CAIRNGORMS NATIONAL PARK AUTHORITY

Title: REPORT ON CALLED-IN PLANNING APPLICATION

DEVELOPMENT PROPOSED: FORMATION OF ACCESS ROAD AND FOUR HOUSE PLOTS, LAND 150 METRES SOUTH OF ST VINCENT'S HOSPITAL, GYNACK ROAD, KINGUSSIE

REFERENCE: 08/184/CP

Figure 8 Layout showing re-arranged plots

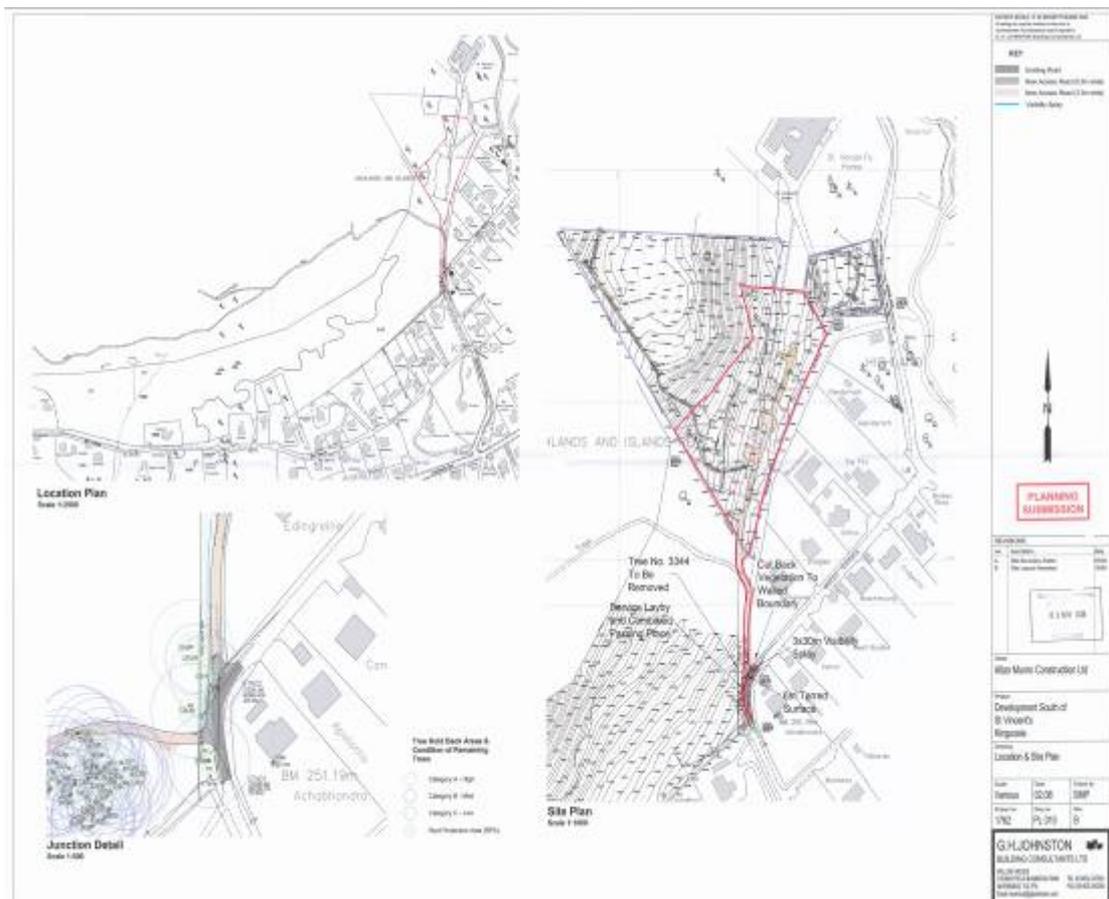
3. This application for 4 houses seeks full planning permission but only for the access and 4 plots. Concern had been raised by Highland Council's Forestry Officer about significant trees in the north western area of the site to be removed. As a result of this the plot layout has been amended (see fig 8) which indicates the ability to retain of a number of trees that receive Category A & B ratings in the Tree Survey. This results in a smaller number of trees being removed but these are of the lower category C rating in the tree report. Another key aspect regarding the call-in of this application related to the access proposals. As per the 4 plots on West Terrace (see Paper 2 and fig 6 of this report) one option was to share a 30 metre long adoptable access road at 5.5 metres wide to gain access to both this and the West Terrace site. Because of the concerns raised regarding potential removal of trees and disturbance to vegetation the Area Roads have agreed to an unadoptable access to each site. In this case, that means that the existing track which gives access to the site from Ardvonie Road would be used. The first 6 metres will be tarmaced and 5.5 metres wide but beyond this a permeable surface would be used with the track being not more than 3.3 metres in width. In addition layby/passing place will be created at the junction of Ardvonie Road and Middle Terrace (see fig 8).

50. Area Roads find the arrangements set out in figure 8 of this report generally acceptable. However, as per the West Terrace proposal the Area Roads Manager seeks full engineering drawings to be provided under planning conditions.
